Drawing Change Notice

CHANGE DOCUMENT NO.
24590-PTF-VDCN-MS-11-00007

JOB NO.	TITLE FOR CHANGE NOTICE
24590	PTF-FRP-VSL-00002D REDESIGN

JUSTIFICATION FOR CHANGE	CAUSE CODE
Based on the re-analysis of FRP-VSL-00002A/B/C/D, per calculation 24590-PTF-MVC-FRP-00003, for revised seismic conditions and design evolution, a redesign of the vessel is required.	01-23

24590-QL-SRA-MTF5-00001-29-01

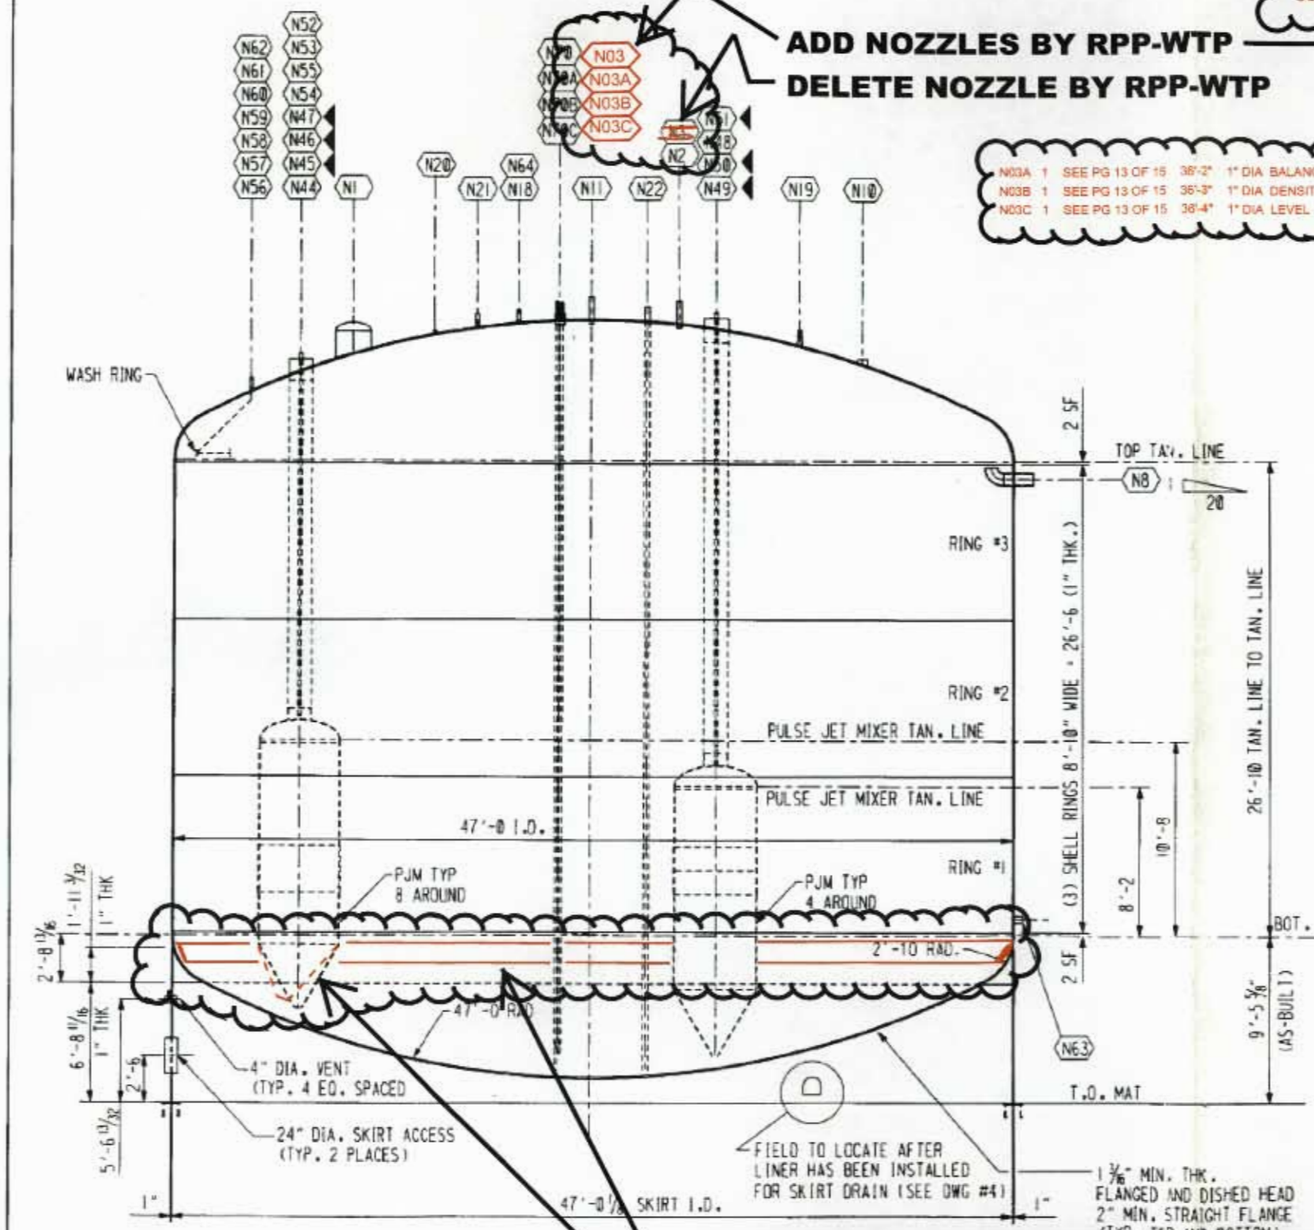
1. **Affected Document: 24590-QL-SRA-MTF5-00001-29-01 (see Attachment 1, page 1 of this VDCN).**

a) Bill of Materials block: Revise the following line Items:

Line Item N3 Elevation block: 35'-3" from 35'-4 5/16".

Line Item N3 Description / Service block: INSTRUMENTATION from SPARE CAPPED.

b) Bill of Materials block: Add the following line Items:

c) Elevations:

Delete Nozzle N3 bubble from N2 bubble column.

Add Nozzle bubble number N03, N03A, N03B and N03C to N70 bubbler column.

Add Knuckle Stiffener plates shown on Attachment 1, page 12 of this VDCN.

Revise Outer PJM nozzle cone to eccentric from concentric shown on 24590-PTF-VDCN-MS-00003, Attachment 1, page 12, Elevation Assemblies A & B.

24590-QL-SRA-MTF5-00001-24-06 REV 00B

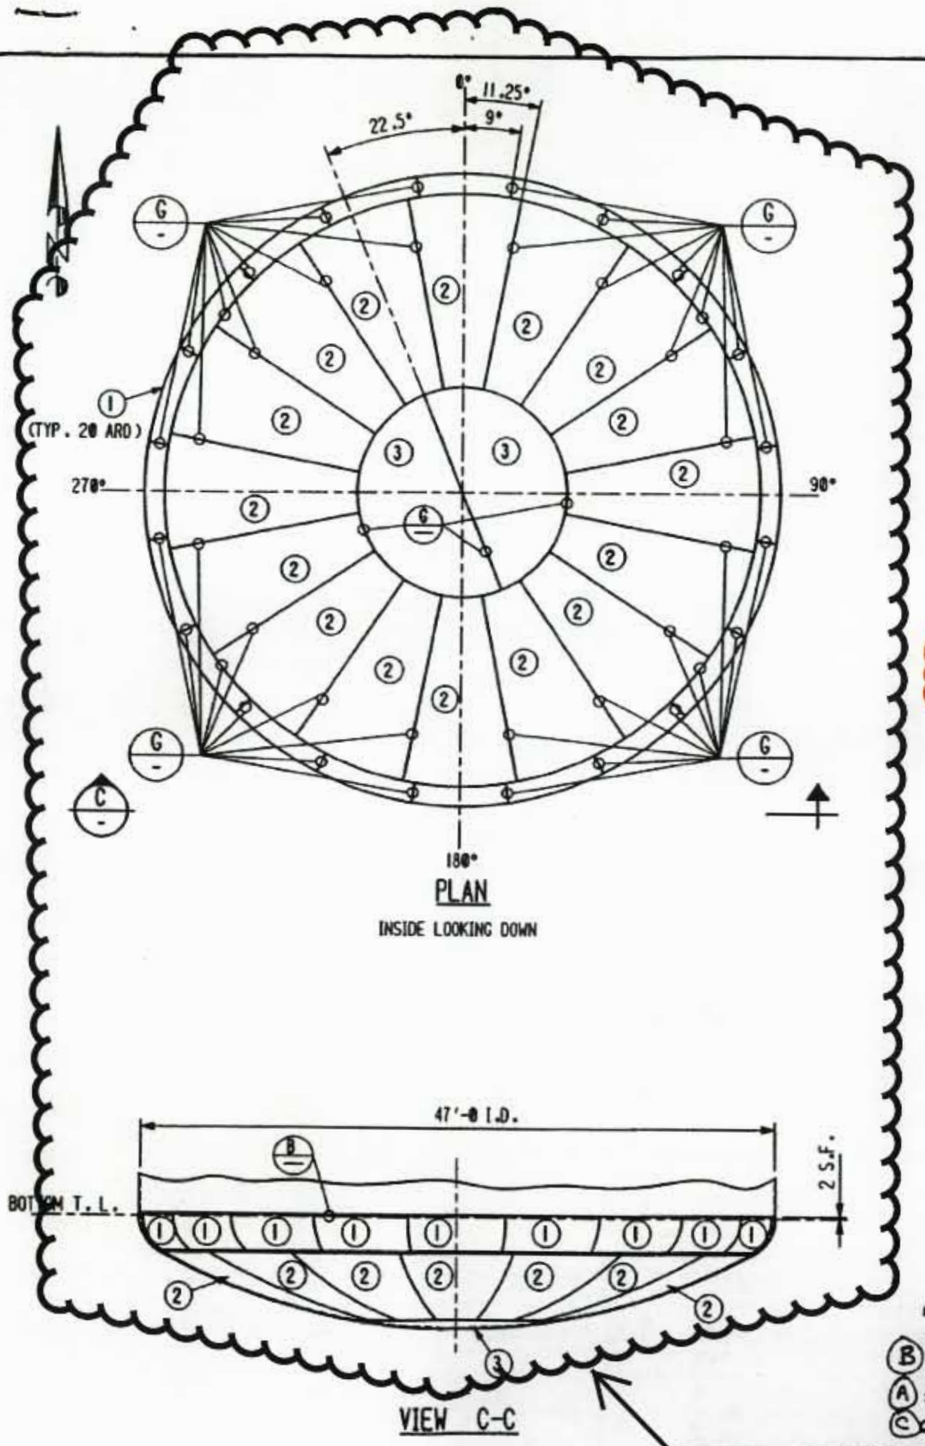
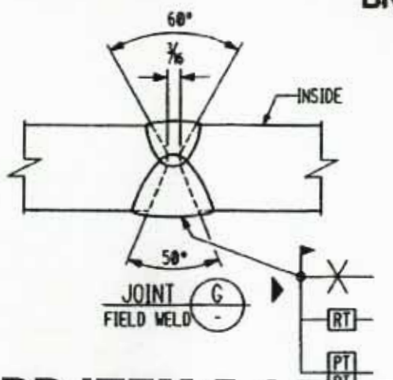
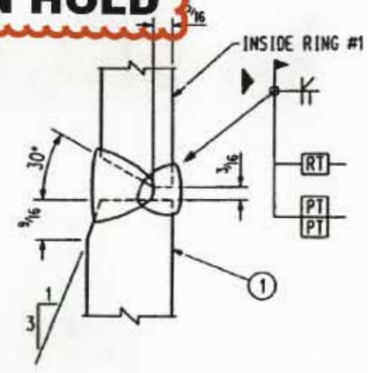
2. Affected Document: 24590-QL-SRA-MTF5-00001-29-06 (see Attachment 1, page 2 of this VDCN).

a) Bill of Materials block: Add Item 5-4 shown on Attachment 1, page 12 of this VDCN.

b) Plan View: Add Knuckle Stiffener plates shown on Attachment 1, page 12 of this VDCN.

c) View C-C: Add Knuckle Stiffener plates shown on Attachment 1, page 12 of this VDCN.

ADD ITEM 5-4 BY RPP-WTP

ADD KNUCKLE STIFFNER PLATES BY RPP-WTP ON HOLD

24590-QL-SRA-MTF5-00001-29-17
REV 00 B

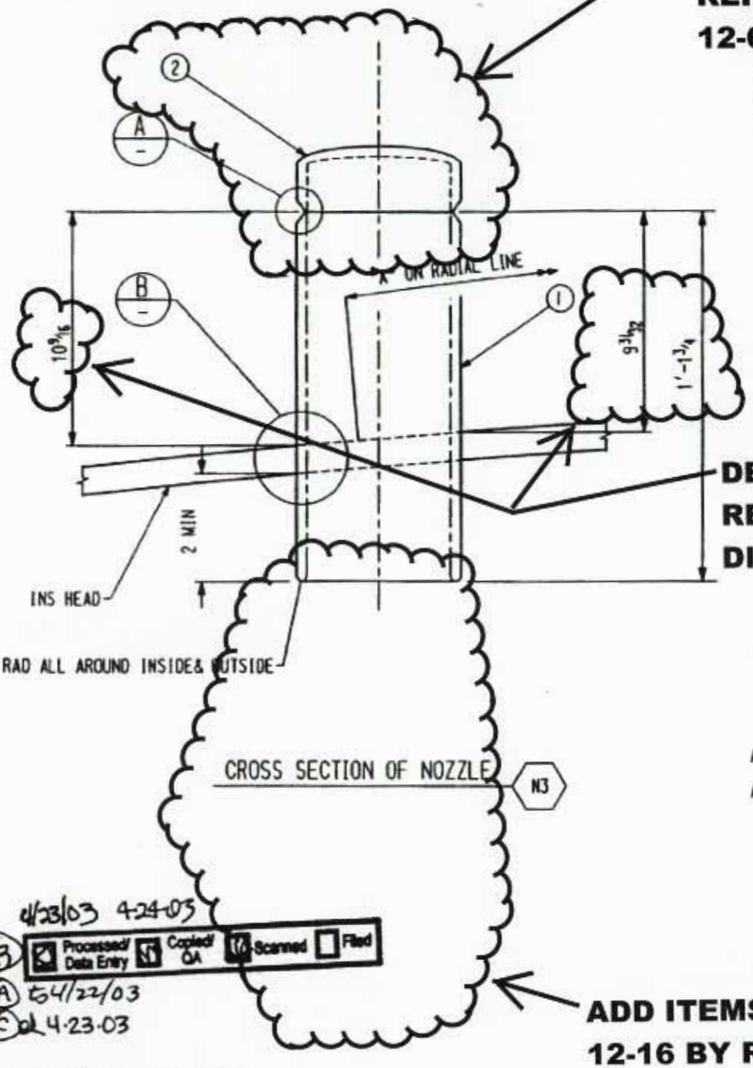
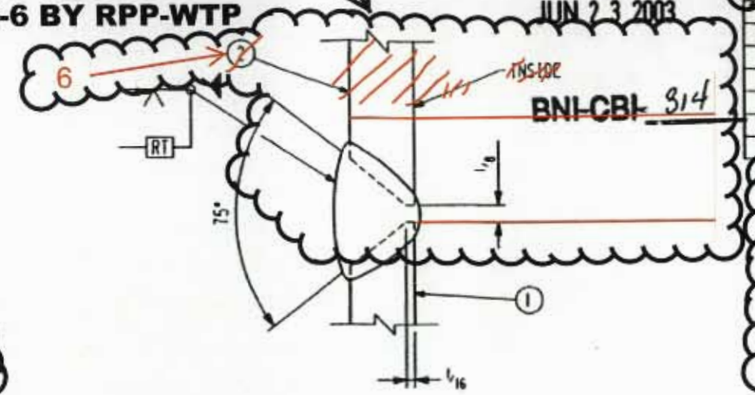
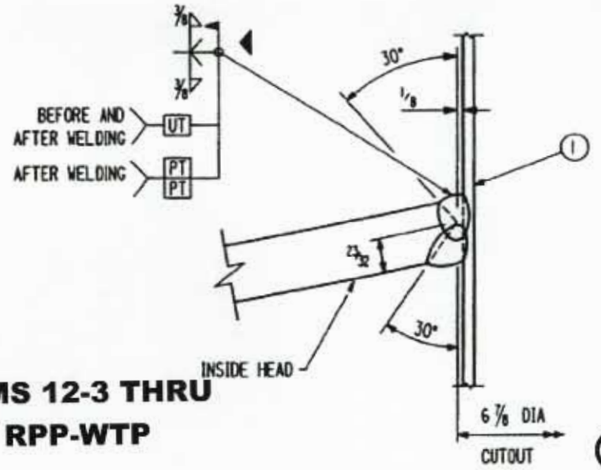
4. Affected Document: 24590-QL-SRA-MTF5-00001-29-17 (see Attachment 1, page 4 of this VDCN).

c) Joint A: Replace Item 2 (Cap) with Item 6 (Plate), including updating depiction to new instrument nozzle as shown on Attachment 1, page 13 of this VDCN.

d) Cross Section of Nozzle view: Delete the following shown on Attachment 1, page 13 of this VDCN.

e) Cross Section of Nozzle view: Add Item, Dimension, and Dip Pipe supports shown on Attachment 1, page 13 of this VDCN.

g) Nozzle N3 Assembly Drawing: Add View, Details, and Sections and Item shown on Attachment1, page 13 of this VDCN.

DELETE ITEM 12-2

DELETE ITEM 12-2
REPLACE WITH ITEM
12-6 BY RPP-WTP

ADD ITEMS 12-3 THRU
12-18 BY RPP-WTP

ADD DETAIL 1, VIEWA-A,
SECTIONS B-B, C-C, D-D
AND ITEM 16 BY RPP-WTP

ADD ITEMS 24 THRU 30 TO BOM BY RPP-WTP
24590-QL-SRA-MTF5-00001- 29-21
REV 00 I

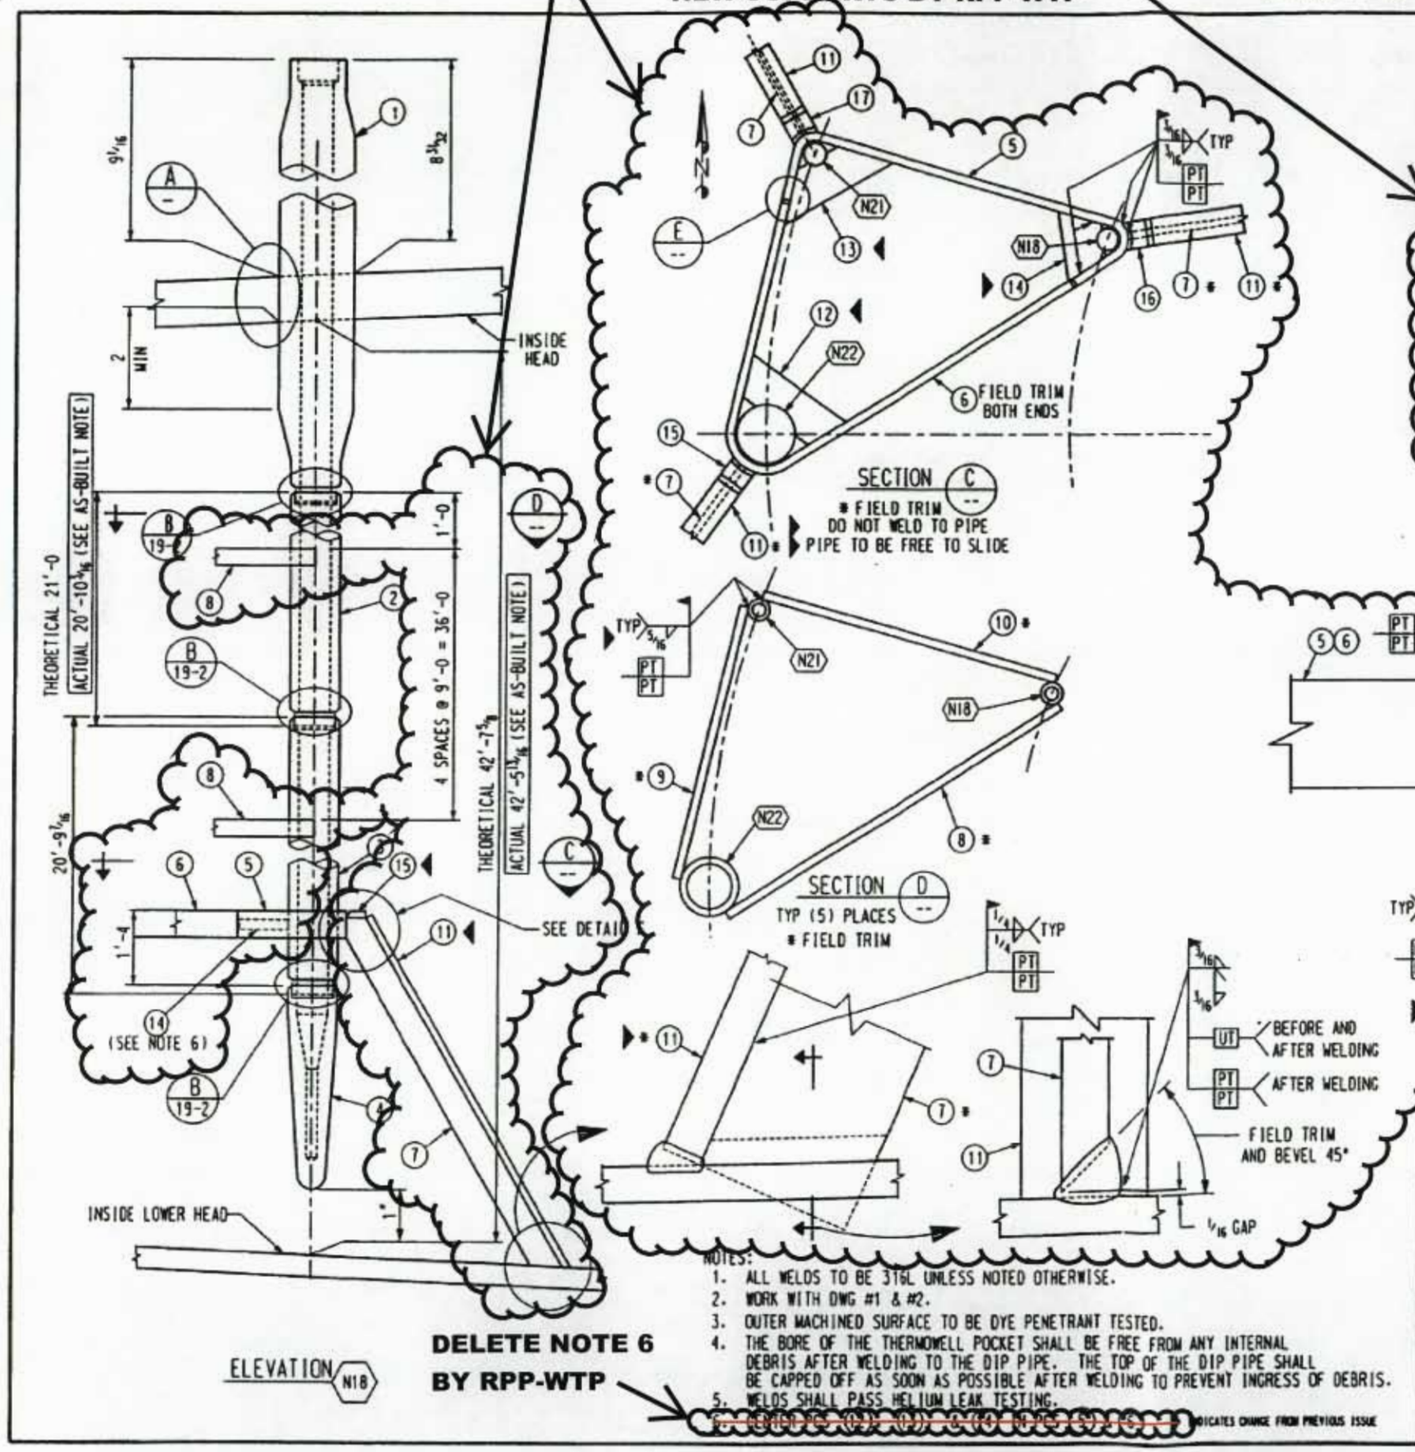
5. Affected Document: 24590-QL-SRA-MTF5-00001-29-21 (see Attachment 1, page 5 of this VDCN).

d) Cross Section of Nozzle view: Delete the following Items and Detail view:

f) Cross Section of Nozzle view: Add the following Section callout:

g) Cross Section of Nozzle view: Revise the following dimensions:

h) Cross Section of Nozzle view: Add the following Section, view, dimensions, and support shown on Attachment 1, page 14 of this VDCN.

i) Nozzle N70 Assembly Drawing: Add Detail, and Section and Item shown on Attachment1, page 14 of this VDCN.

DELETE AND REPLACE WITH NEW SUPPORTS BY RPP-WTP

24590-QL-SRA-MTF5-00001-29-23
REV 00 H

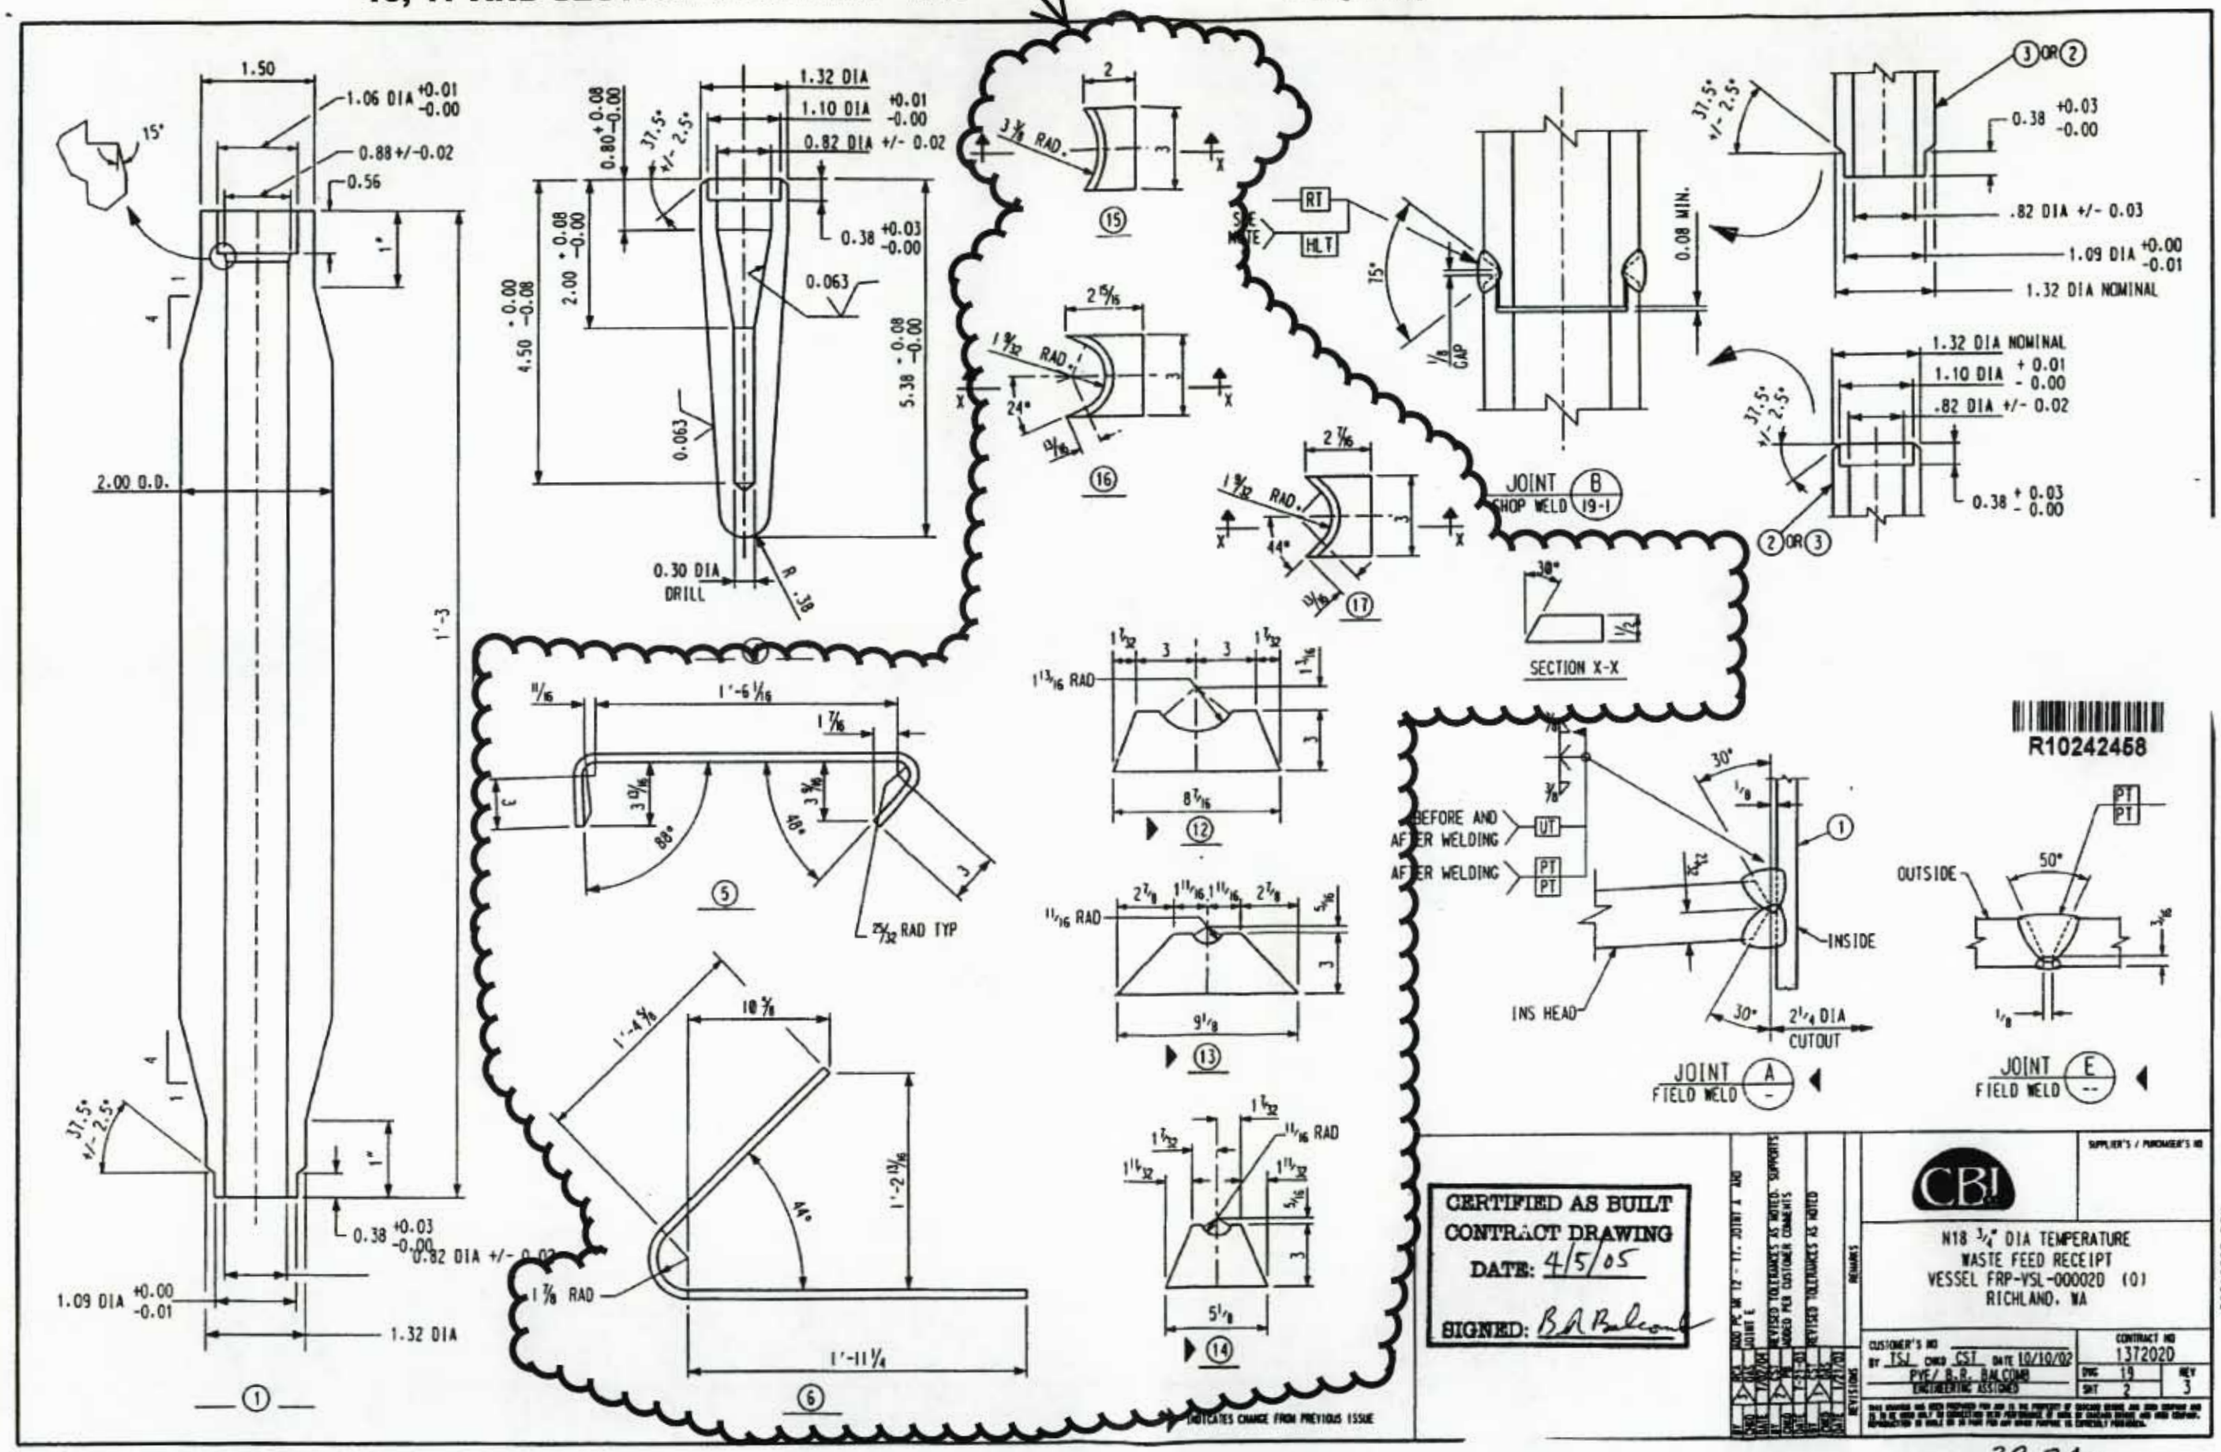
7. Affected Document: 24590-QL-SRA-MTF5-00001-29-23 (see Attachment 1, page 7 of this VDCN).

c) Elevation view: Add the following Items shown on Attachment 1, page 14 of this VDCN.

d) Elevation view: Delete the following Items:

e) N18 3/4" DIA Temperature Drawing: Delete the following Detail and Sections:

f) N18 3/4" DIA Temperature Drawing: Add the following Item:

DELETE ITEMS 5, 6, 12, 13, 14, 15, 16, 17 AND SECTION X-X BY RPP-WTP
